Sec. 4-3-31. Applicability; adoption of residential code; amendments.

- (a) This section is applicable to all structures within the City described herein as one-and two-family dwellings and townhouses not more than three (3) stories in height.
- (b) There is hereby adopted the *International Residential Code*, 2015 2021 edition (as published by the International Code Council), excluding Part VIII Electrical (Chapters 34-43), and including Appendices A-J, copies of which shall be maintained by the Building Official, with the following amendments:

**Figure 602.6.1
TOP PLATE FRAMING TO ACCOMMODATE PIPING**

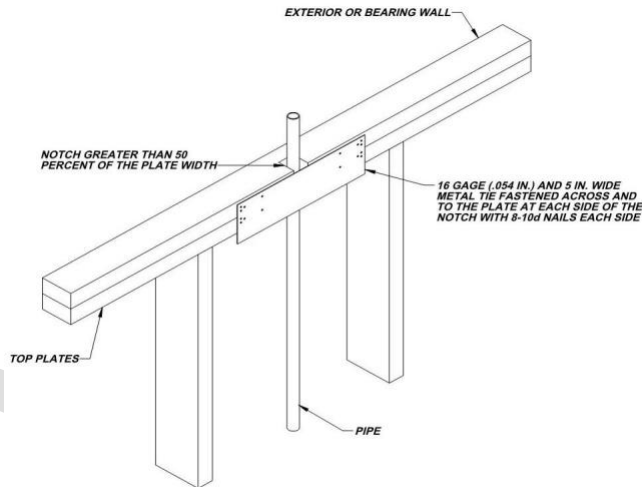
R602.6.1 Drilling and notching of top plate. When piping or ductwork is placed in or partly in an exterior wall or interior load-bearing wall, necessitating cutting, drilling or notching of the top plate by more than 50 percent of its width, a galvanized metal tie not less than 0.054 inch thick (1.37 mm) (16 Ga) and 1 ½ inches (38 mm) 5 inches (127 mm) wide shall be fastened across and to the plate at each side of the opening with not less than eight 10d (0.148 inch diameter) ~~nails having a minimum length of 1½ inches (38 mm) or eight (#10) wood screws having a minimum length of not less than 1½ inch (38 mm)~~ at each side or equivalent as approved by the Code Official. Fasteners will be offset to prevent splitting of the top plate material. The metal tie must extend a minimum of 6 inches past the opening. See figure R602.6.1. *{Remainder unchanged}*
